Camden Town Hall Annexe

NMA

Crosstree Real Estate Partners LLP

March 2017

## Euston Road Facade

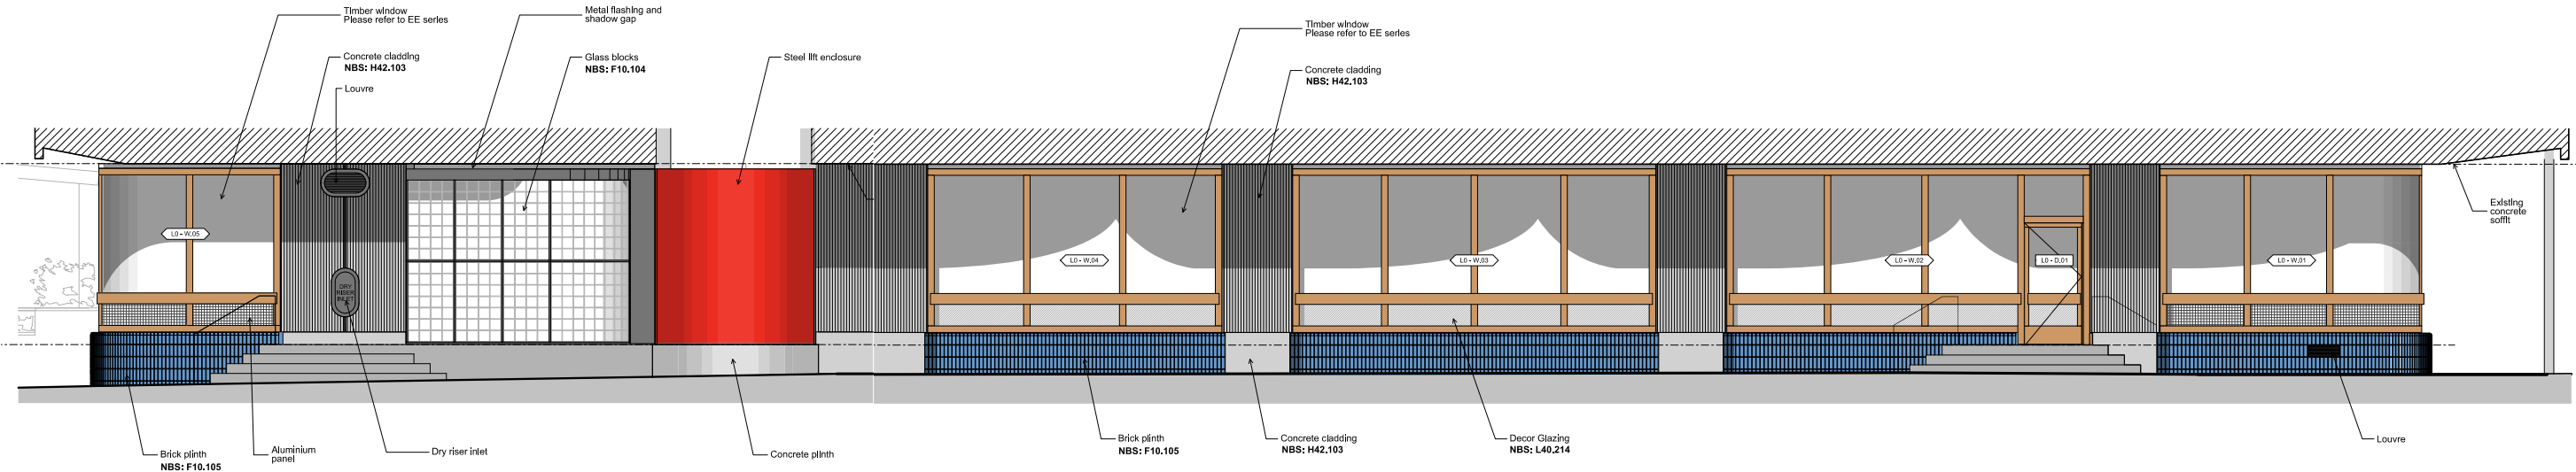
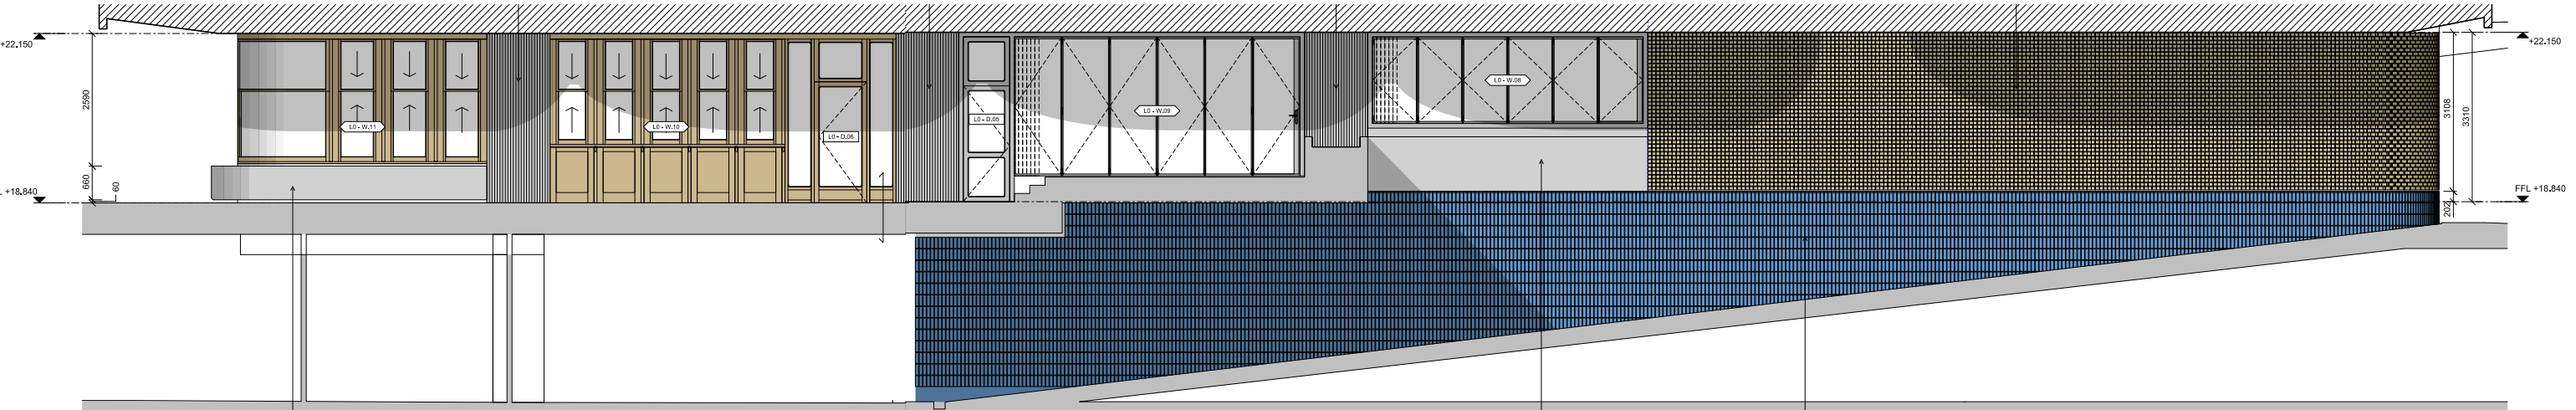
The following elevations show the proposed changes to the ground floor facade treatment, which has been developed to be more attuned to the existing building.

Lift lobby / lift enclosure - Approved

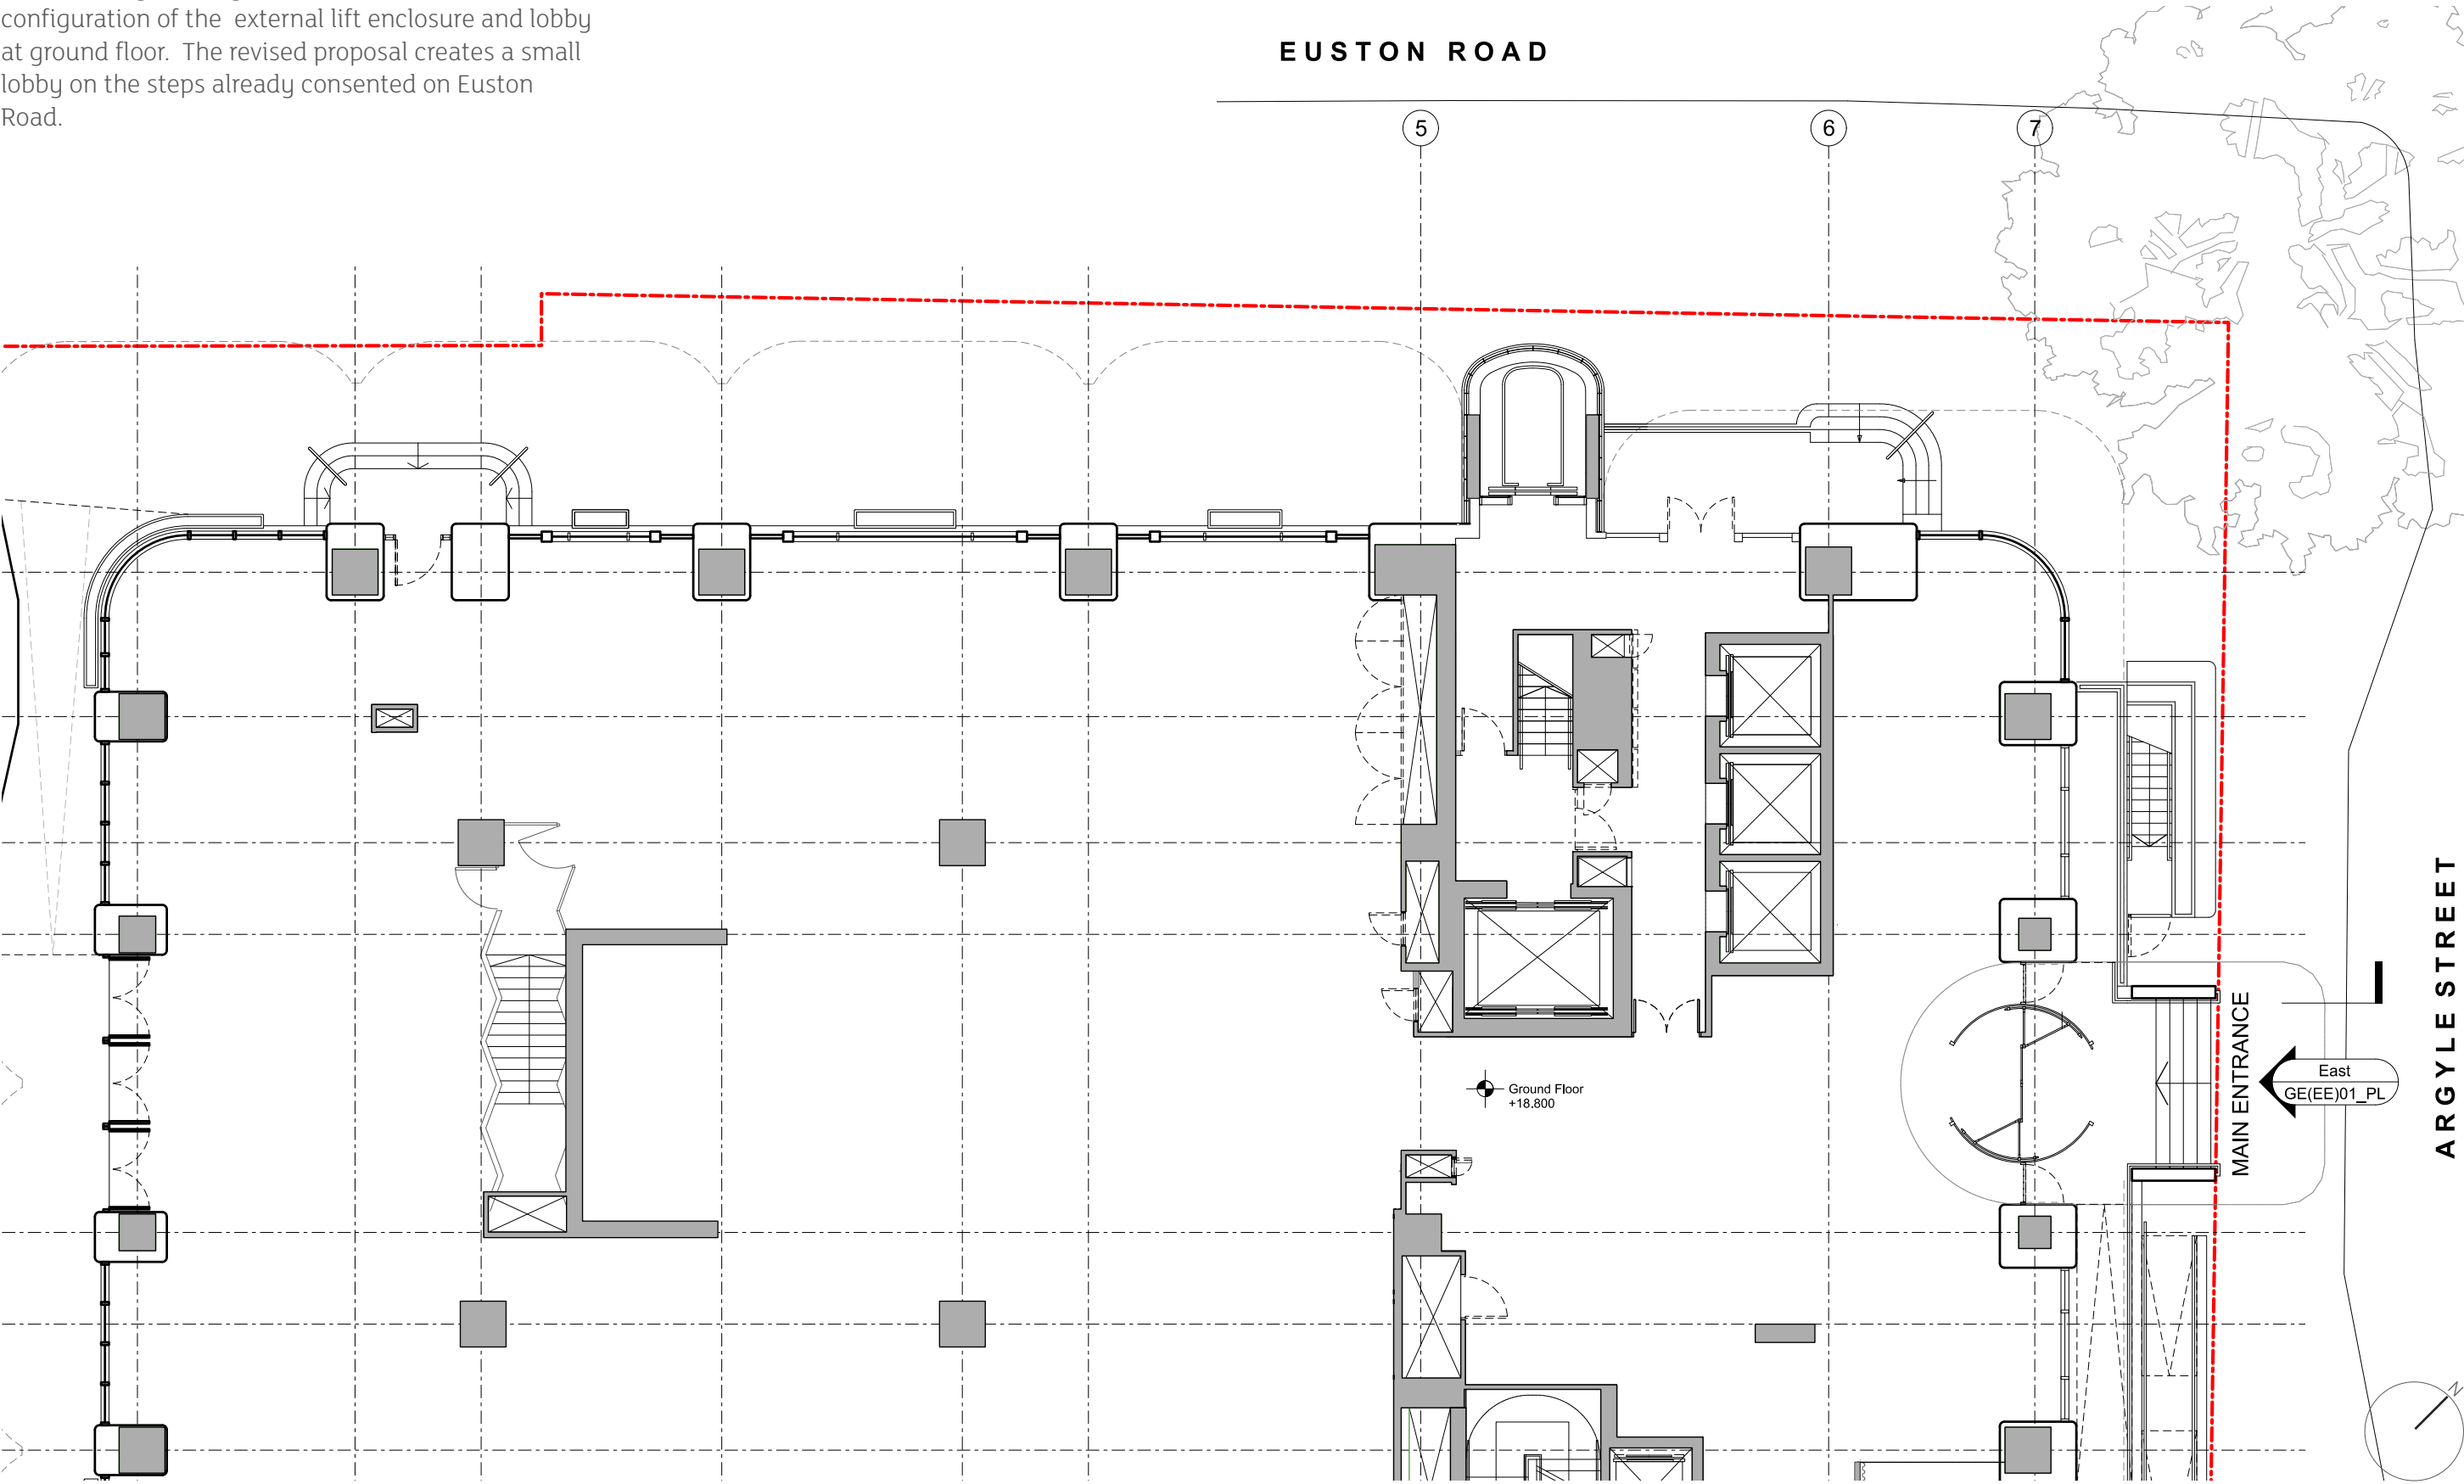
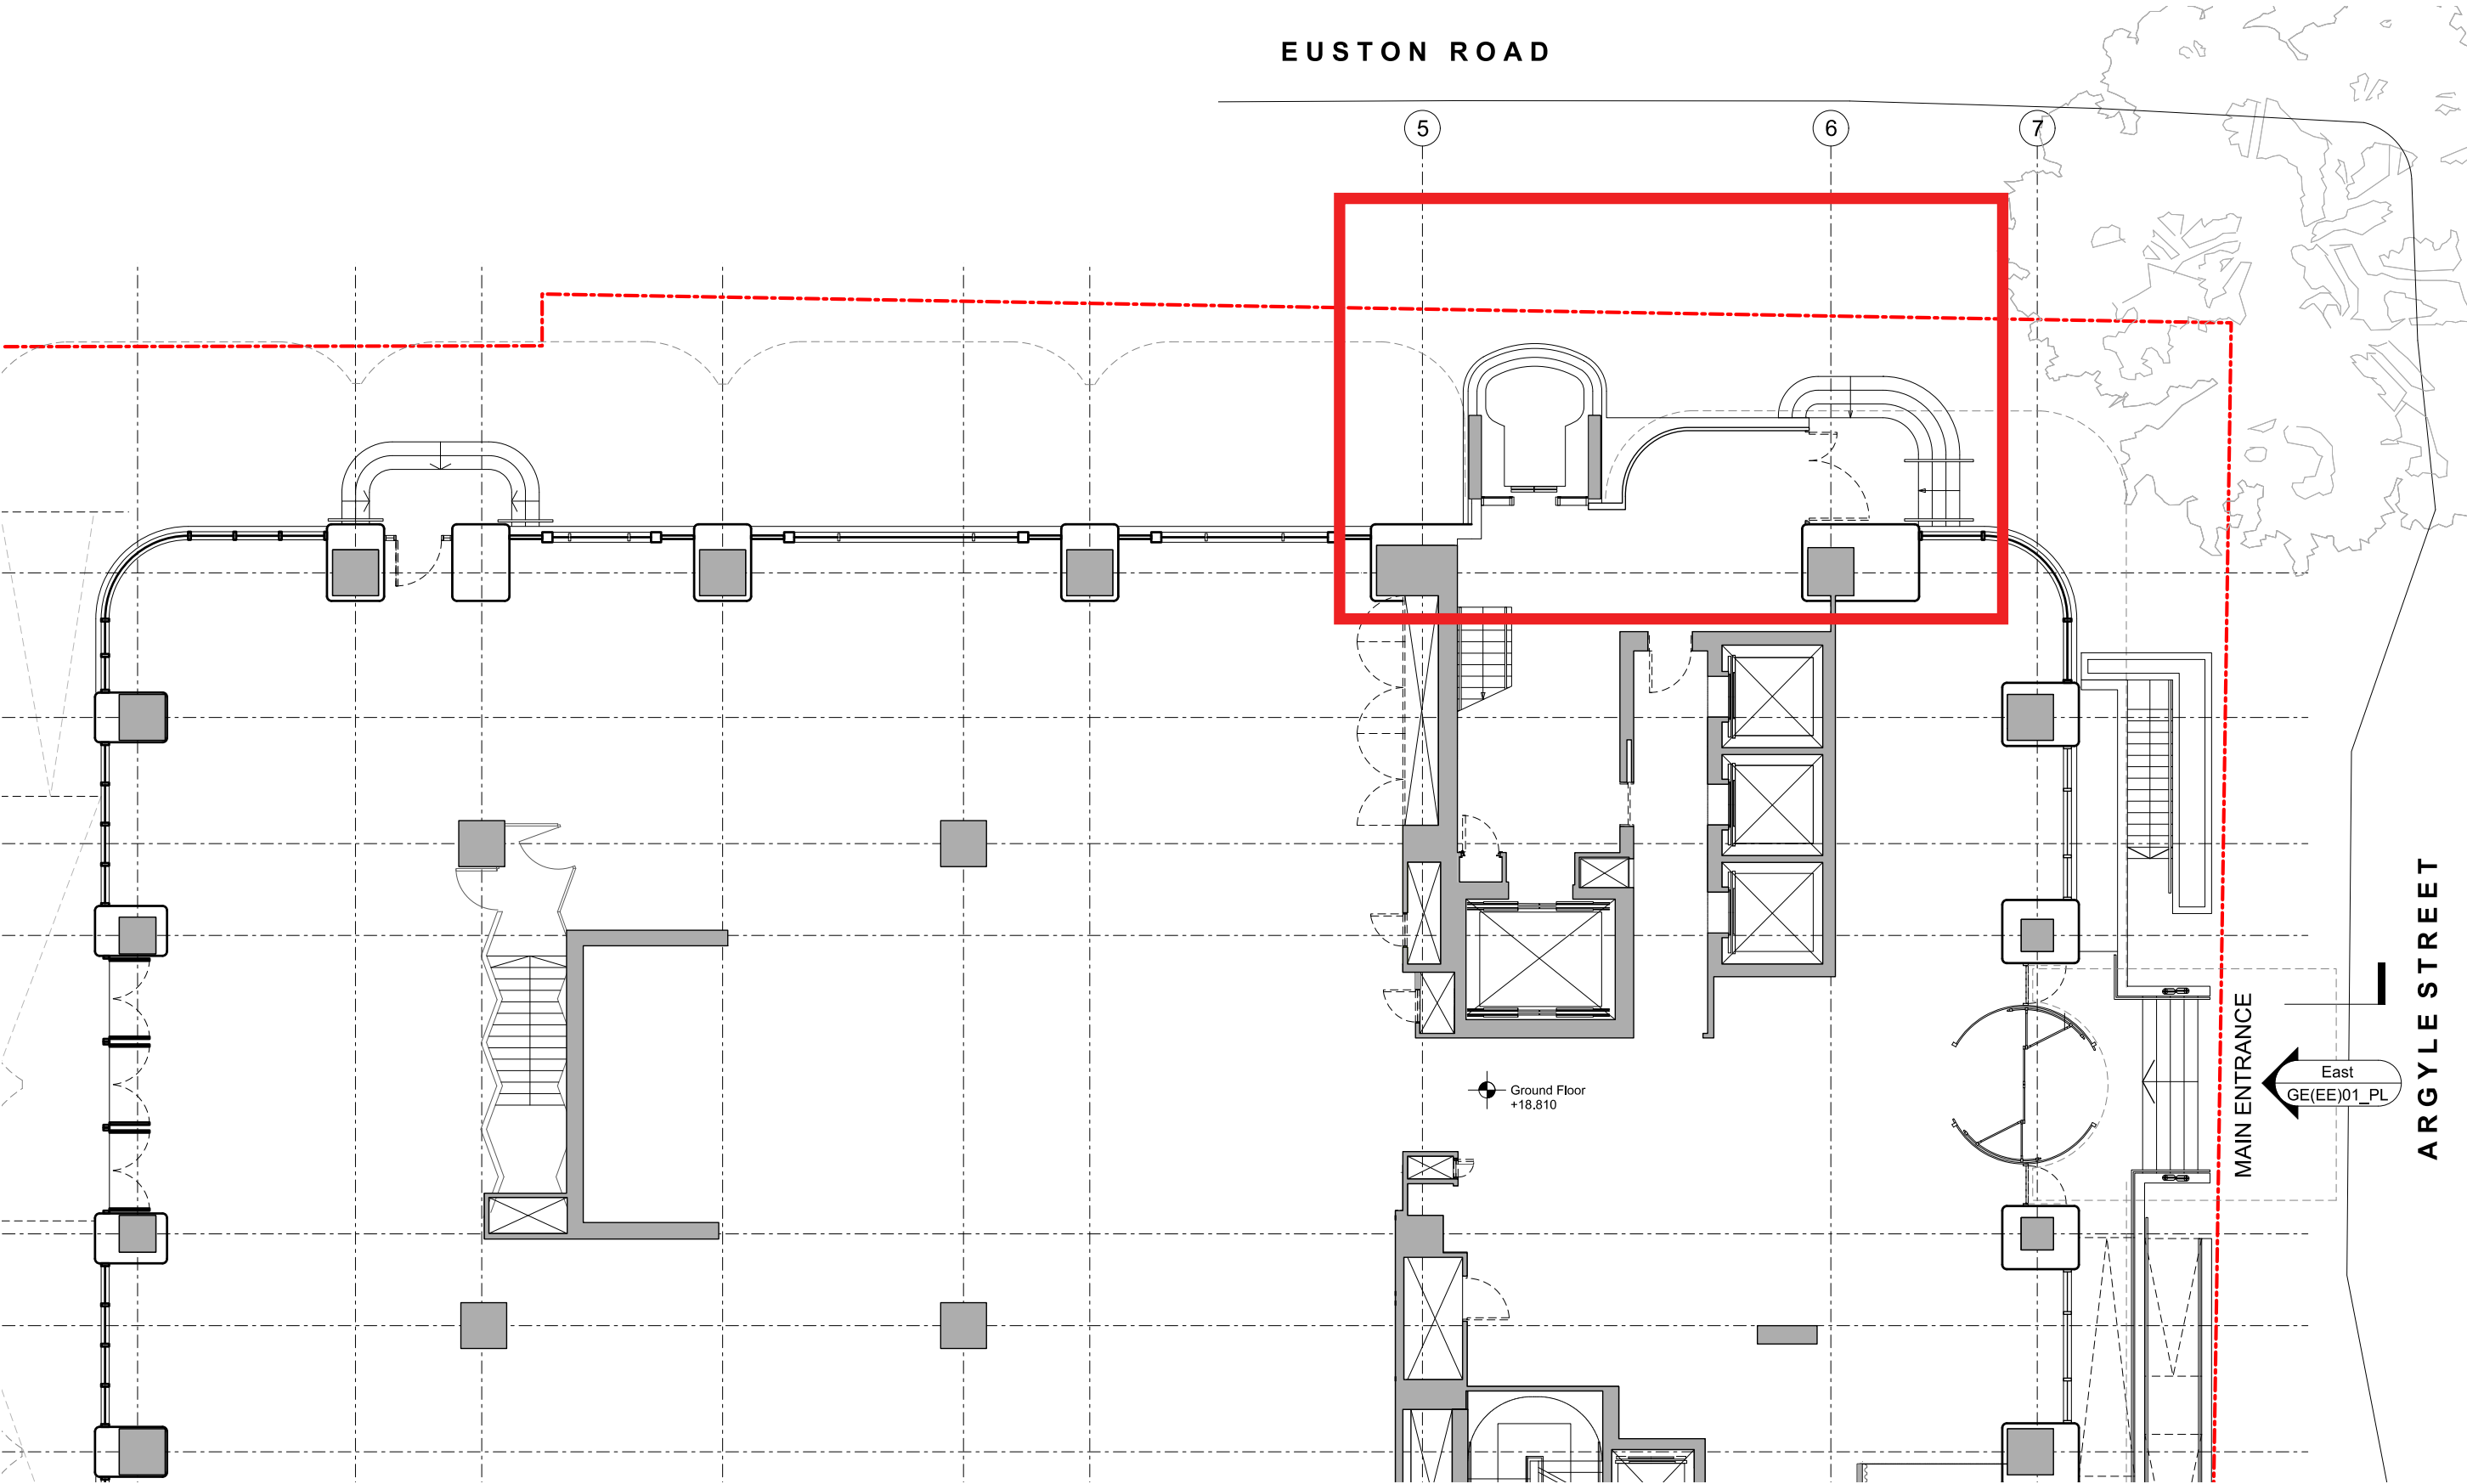
The following drawing shows the consented configuration of the external lift enclosure and lobby at ground floor. The revised proposal creates a small lobby on the steps already consented on Euston Road.
